**AMENDMENT 5**

**Invitation for Bid (IFB)  
UOG IFB No. B23-01**

UOG INVITATION FOR BIDS NO. B23-01:  
MULTI-STEP SEAL BID FOR CONSTRUCTION SERVICES

**QUESTION & ANSWER SHEET NO. 3**  
**July 25, 2023**

# 2EP101

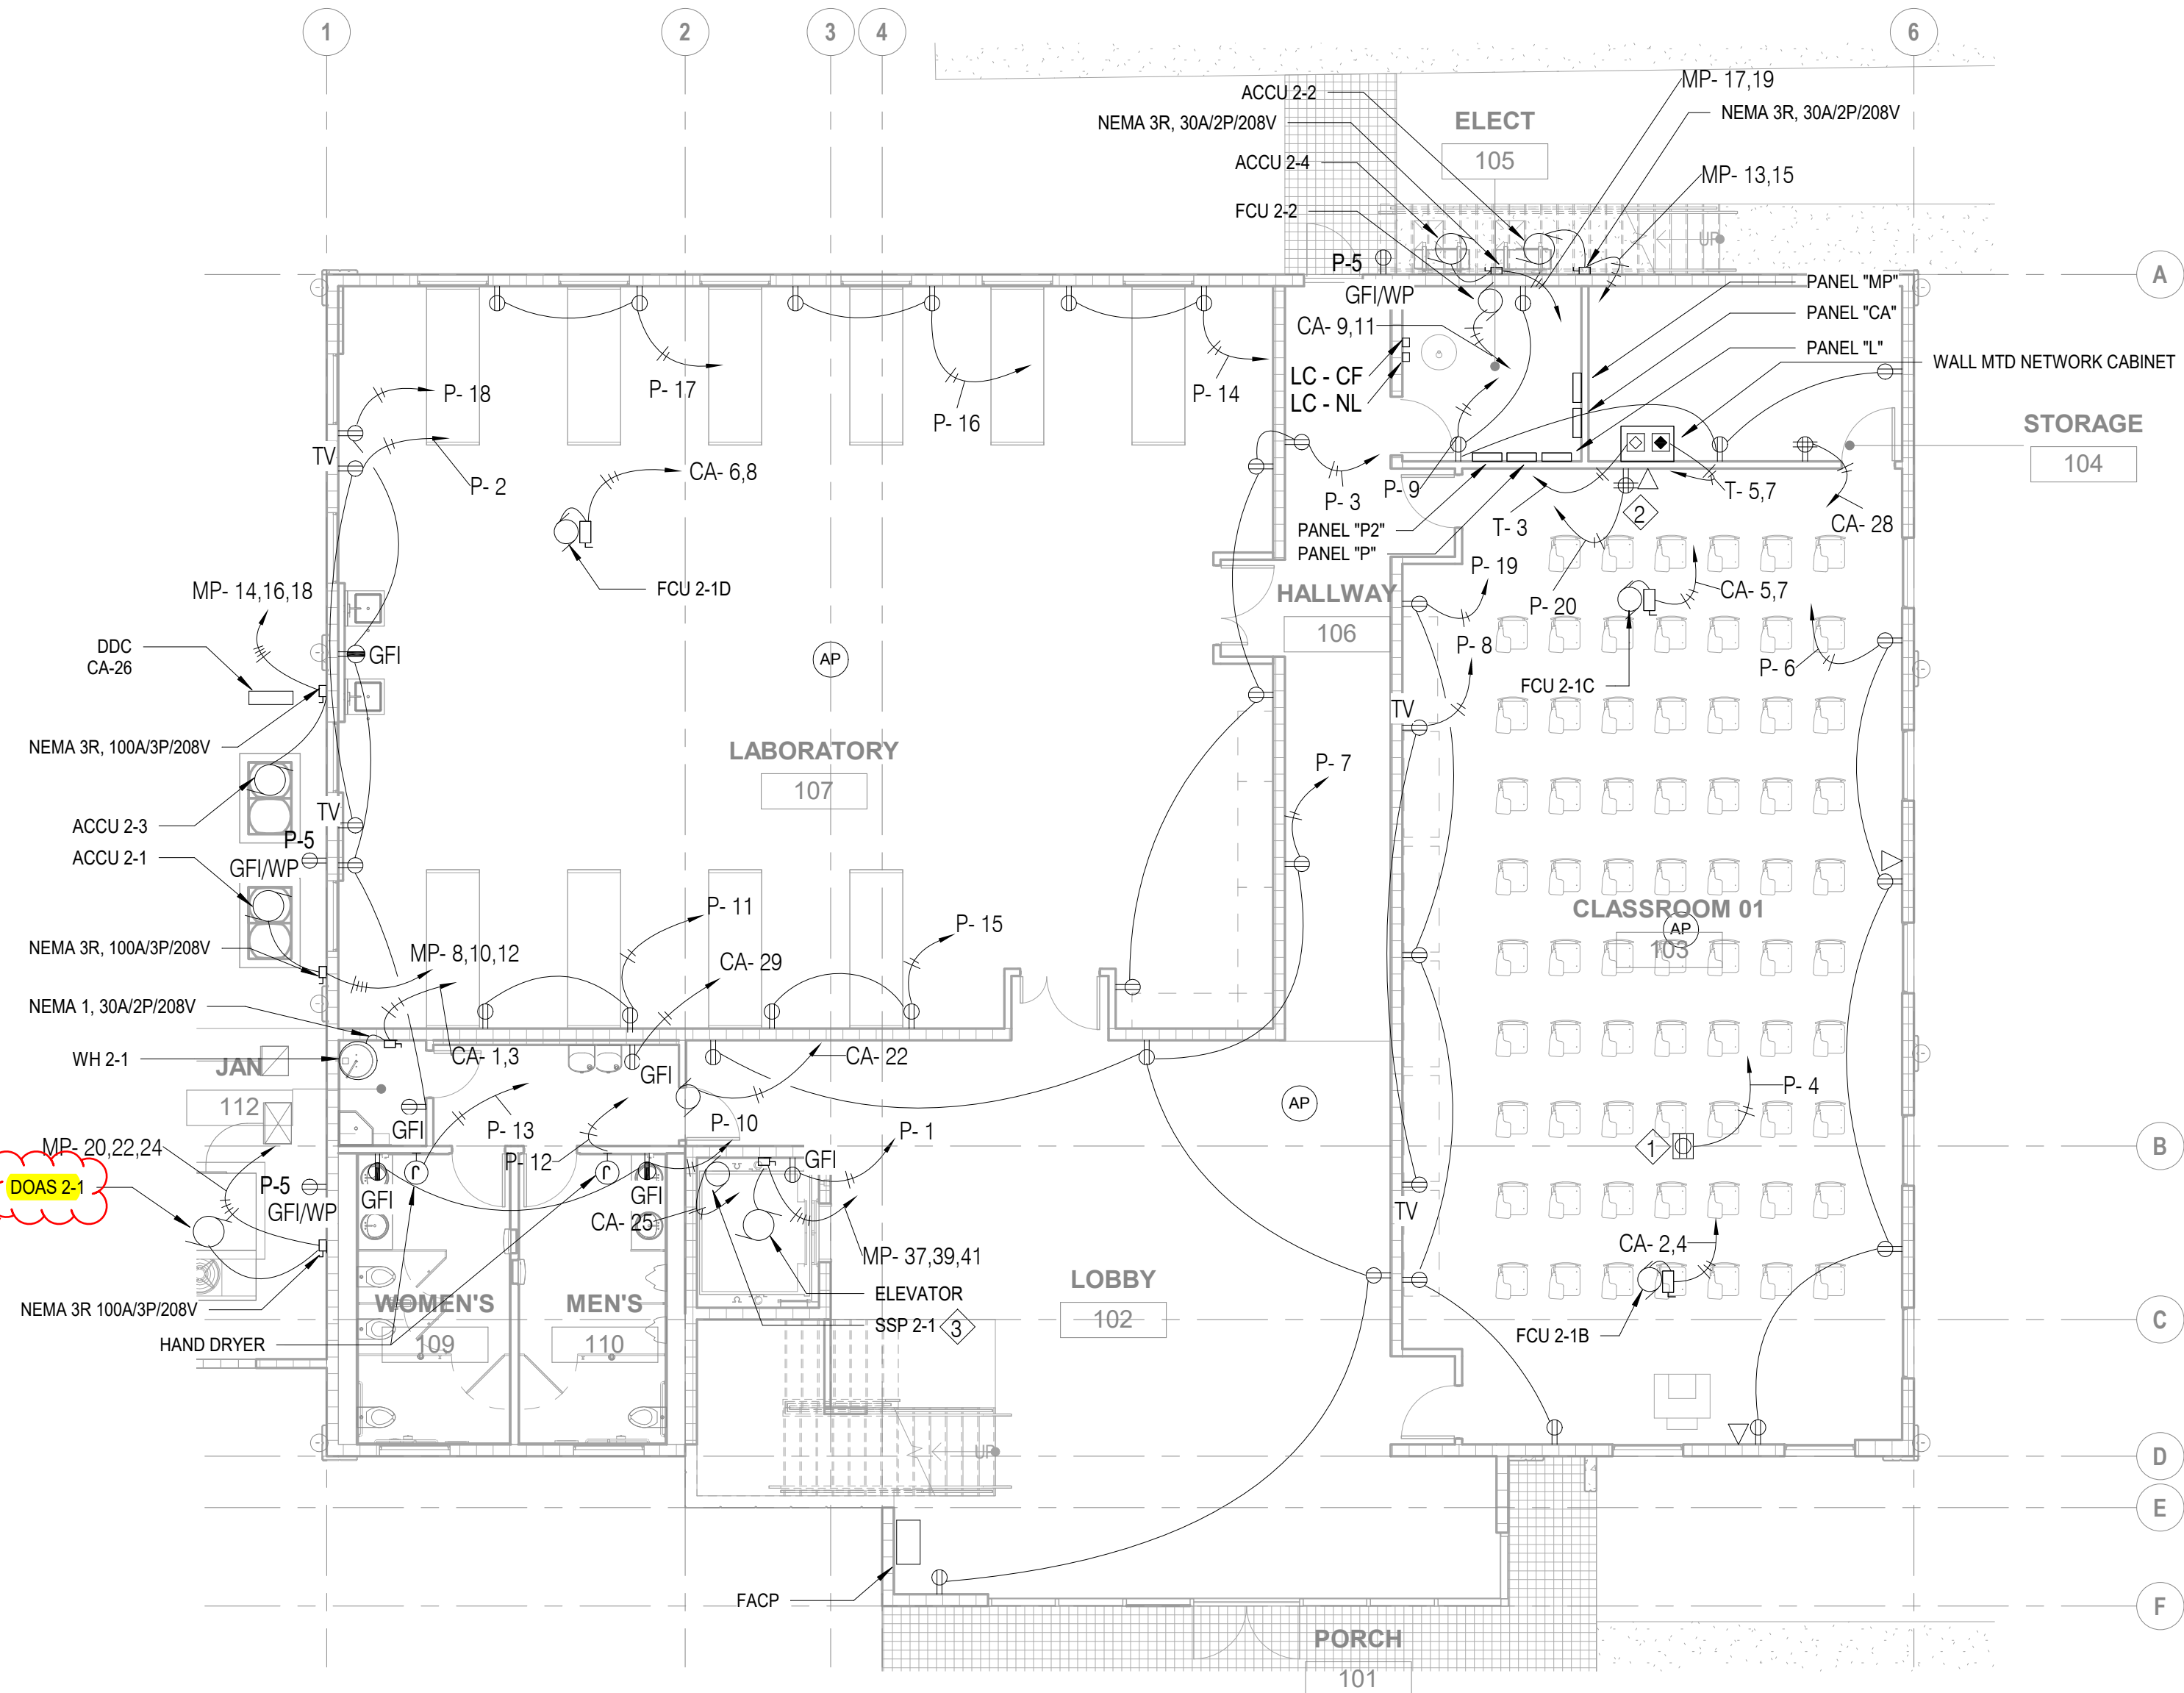
Confirm if this is DOAS 2-3 as indicated on the Schedule of Loads for Panel "MP"

DOAS 2-1

DWG NO:  
**2EP101**

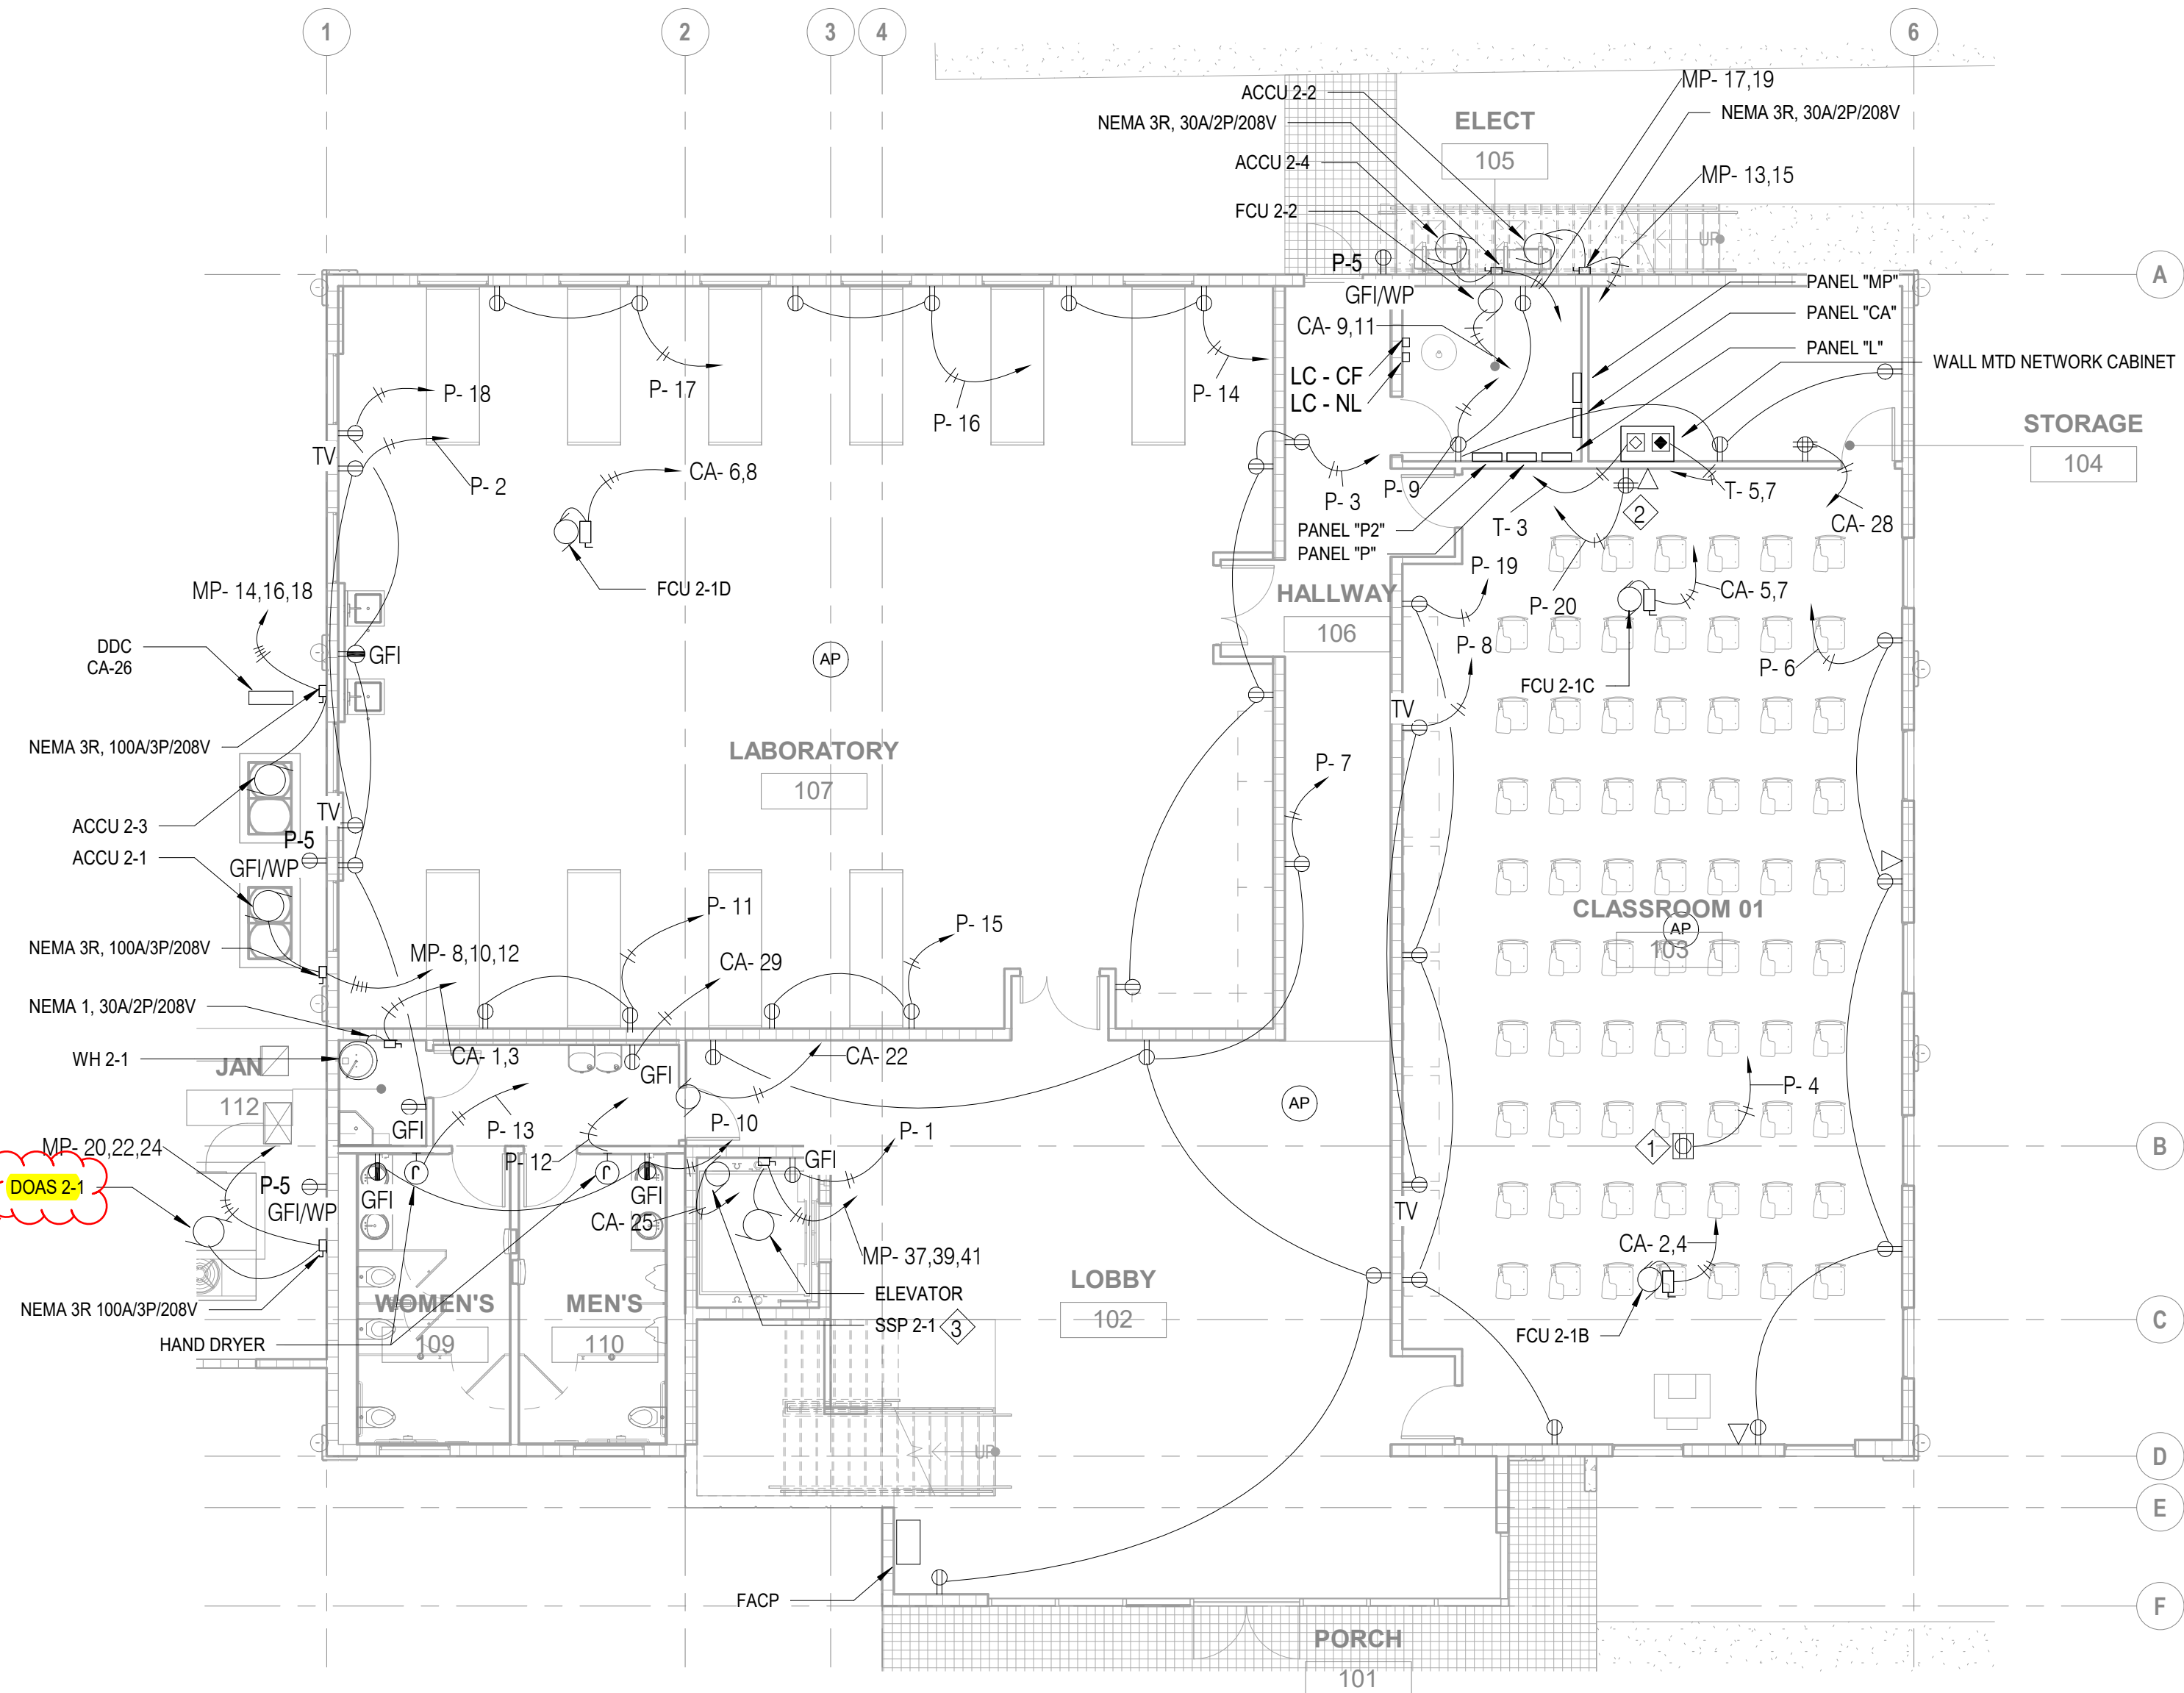
Confirm if this is DOAS 2-3 as indicated on the Schedule of Loads for Panel "MP"  
 Per Mechanical plans, DOAS 2-1 is correct
